IHE Change Proposal

IHE Domain	Patient Care Device (PCD)
Change Proposal ID:	CP-PCD-nnn
Change Proposal Status:	Draft
Date of last update:	2023-03-16
Person assigned:	Brian Witkowski

PCD TF Vol2 – PCD-03 appendix example corrections	
Submitter's Name(s) and e-mail address(es):	Brian Witkowski, brian_witkowski@baxter.com
Submission Date:	xxxx-xx-xx
Integration Profile(s) affected:	Point-of-Care Infusion Verification (PIV)
Actor(s) affected:	Infusion Order Consumer (IOC)
IHE Technical Framework or Supplement modified:	Appendix E in PCD TF, revision 9.0, dated Dec 12, 2019
Volume(s) and Section(s) affected:	Vol 2, changes and additions to E.2

Section E.2 **E.2.2 Interaction Diagram**, update diagram to include IOC sending Application Acknowledgement to IOP, page 179, line 4565; **E.2.3 Messages**, update HL7 to reflect reality and correct errors:

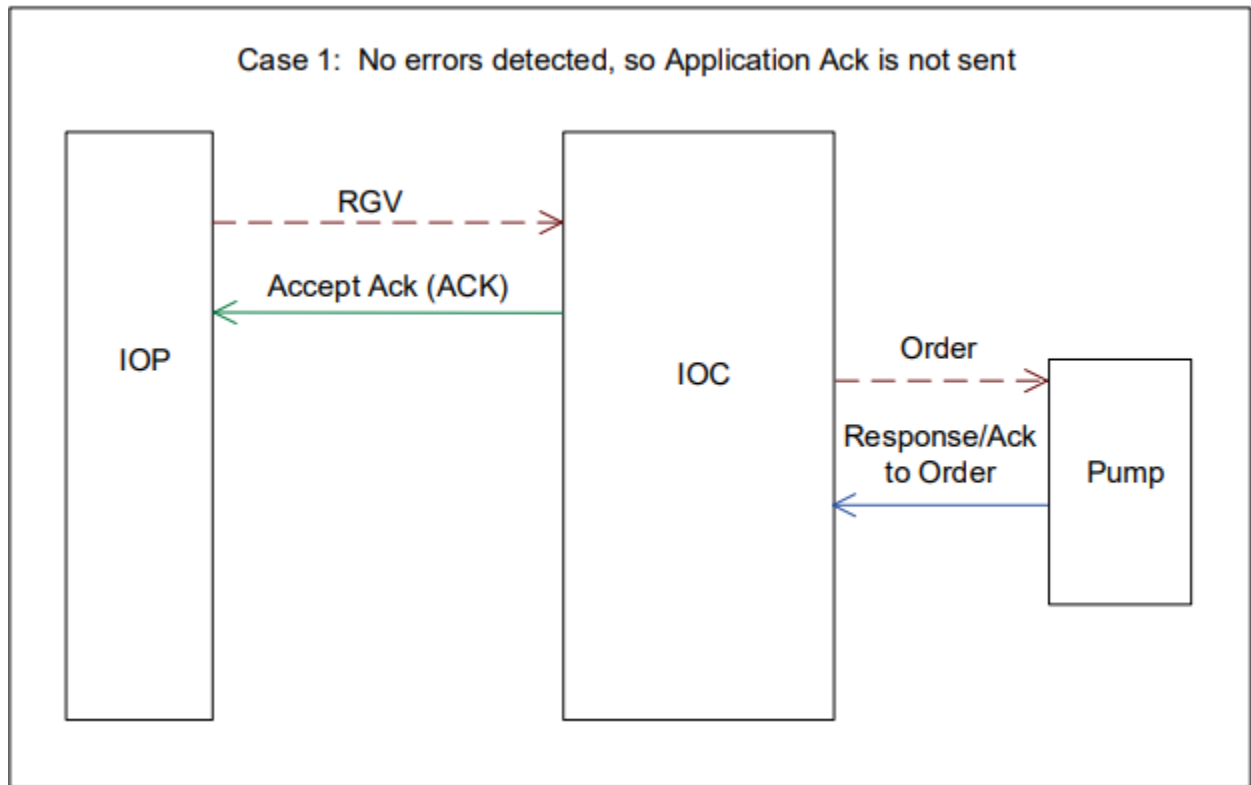
Change

To include a yellow-colored arrow (matching the other examples in this section) pointing one-way from the IOC to the IOP with a label of “Application Ack (RRG)” above it. This arrow and label should be placed below the green arrow with comfortable spacing and the label should have centered text with the other labels above it. Below the yellow arrow, the text “MSA-1 indicates success or failure” should be added. The label at the top of the diagram should also be changed to not state “Application Ack is not sent”, since that is false.

For Case 2 and Case 3 diagrams below this one, add the text “MSA-1 indicates success or failure” below the existing yellow lines for Application Ack (RRG).
